INDESIT company

Model type:
WT102EXP

Commercial code:
F026869

n1040245: Brembate washing machine basket doors re

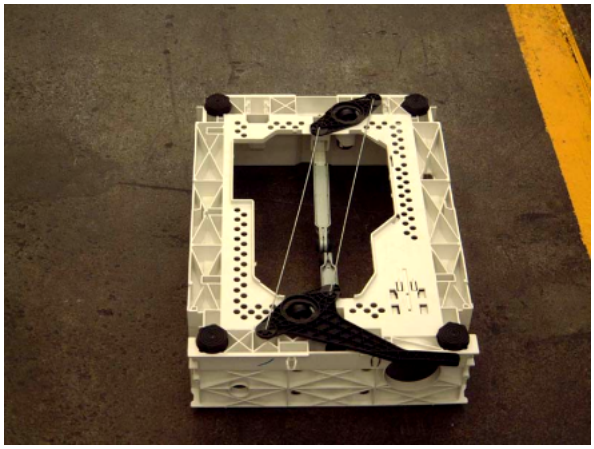
For all washing machine models produced in the Brembate factory and relevant to this note, in replacing the loading mouth code 083895/112743/252375 proceed as follows:
-remove the 18 rivets (9 on the right, 9 on the left) hooking the two doors to the loading mouth on the machine;
-take replacement part 083895/112743/252375 and carry out the same operation described in the previous point;
-hook the two new doors and the new loading mouth on the basket of the machine using the nut and bolts kit code 080691 (formed of 18 screws + 18 washers + 18 nuts);
-use silicone (SAT code 081629) for hooking the loading mouth on the basket.

FIG. 1

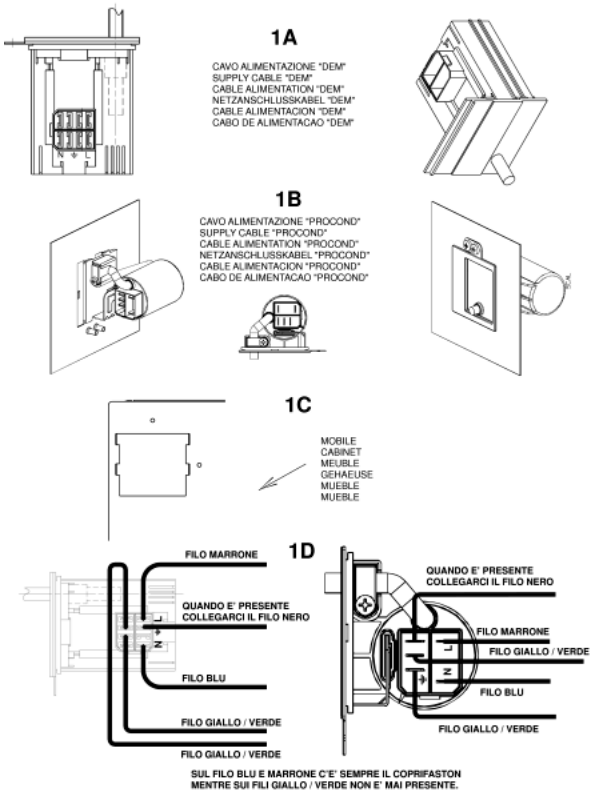
To use premodified wirings on modified products perform the connection to the terminal block of the new cable as shown in fig. 1 - 1D.
The wiring diagrams indicated in the Documentation remain the same.

N1040309FIG1

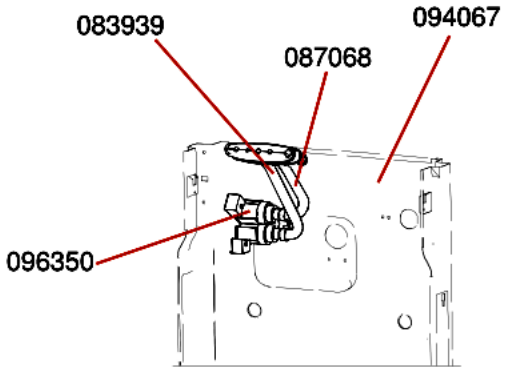
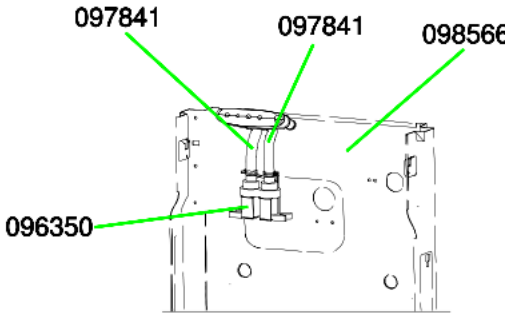
From serial no. 30912.0001, the system used for fixing the loading solenoid valve (spare part code 096350) to the rear panel has been modified on Top Loading washing machines, rotating its position by 90°.
The solenoid valve (spare part code 096350) has been modified with the 45° rotation of a coil; the Replacements Warehouse will continue to manage this part with the same code. When replacing on premodification machines, fit the coils as shown in figure N1040309FIG3-1 and on modified machines, as shown in figure N1040309FIG3-2; to rotate the coil, lift it using a screwdriver and then refit according to the inserts on the plastic.

Replacement codes of the parts affected by this modification (see figure N1040309FIG1):

FIG1 A - PREMODIFICATION STRUCTURE
solenoid valve tube/distributor assembly: premodification 083939;
solenoid valve tube/distributor assembly: premodification 087068;
rear panel: premodification 094067.
FIG1 B - NEW STRUCTURE

solenoid valve tube/distributor assembly: new 097841;
solenoid valve tube/distributor assembly: new 097841;
rear panel: new 098566.

N1040309FIG2

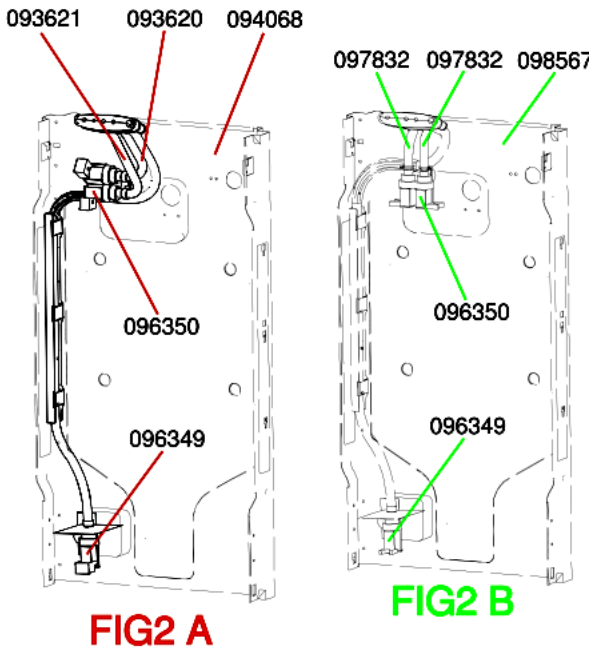
Replacement codes of the parts affected by the modification to WMTL80UK (see figure N1040309FIG2):

FIG2 A - PREMODIFICATION STRUCTURE
solenoid valve tube/distributor assembly: premodification 093620;
solenoid valve tube/distributor assembly: premodification 093621;
rear panel: premodification 094068.
FIG2 B - NEW STRUCTURE
solenoid valve tube/distributor assembly: new 097832;
solenoid valve tube/distributor assembly: new 097832;
rear panel: new 098567.

n1040321: Plastic protecion for solenoid valve.

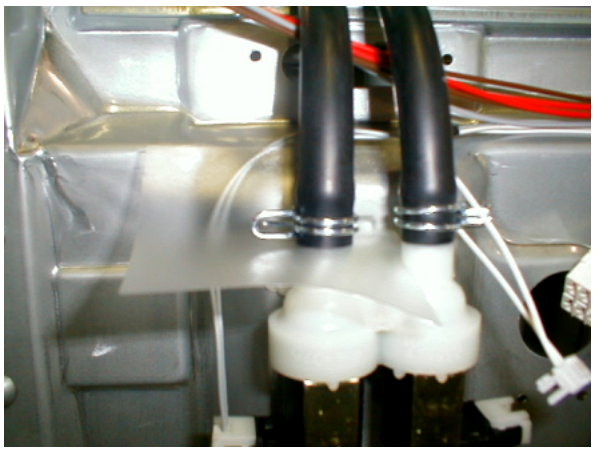
All top-load washing machines produced from September 2003 to February 2004 (from serial no. 30900.0000 to 40300.0000) have been equipped with a plastic protection Service code 109798 (shown in N1040321FIG1), to prevent water from damaging the solenoid valve and electronic card.

N1040324FIG1

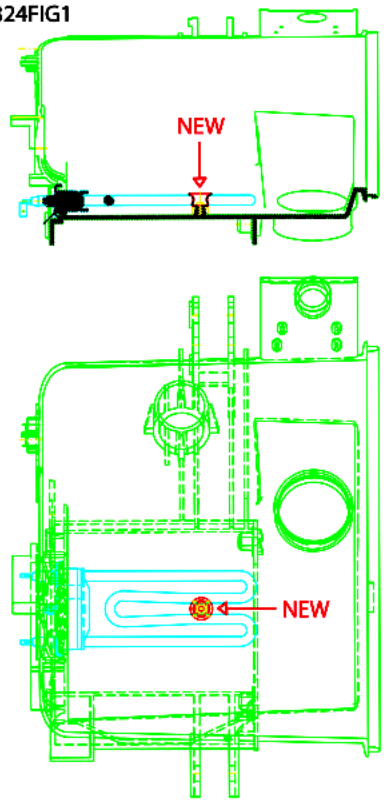
From serial number 40506.0001, the fixing system of the heater to the tank has been modified on all top-load washing machines affected by this note, with the introduction of a metal retainer (image N1040322FIG1 reference NEW) in place of deflector Service code 055322.

The modification has involved both heater and tanks. Given below are the Service codes of the new and old items concerned:

N1040404FIG1

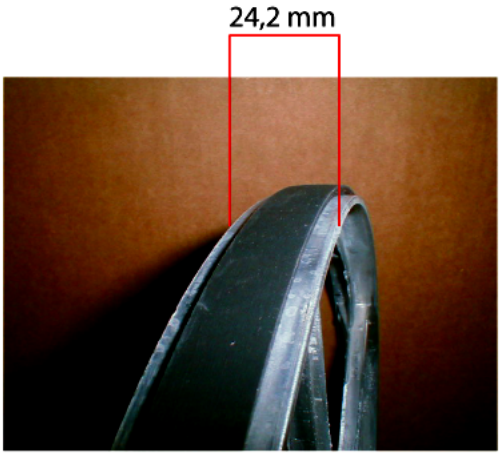
n1040404: New pulley installed on top loading washing machines up to 1000RPM (NO tub lock)

From serial no. 51202.0001 the pulley track has been widened from 21.2mm to 24.2mm (see picture N1040404FIG1).

new pulley
C00142832 - D280 24.2 mm track

Premodification pulley
C00083912 - D280 21.2 mm track
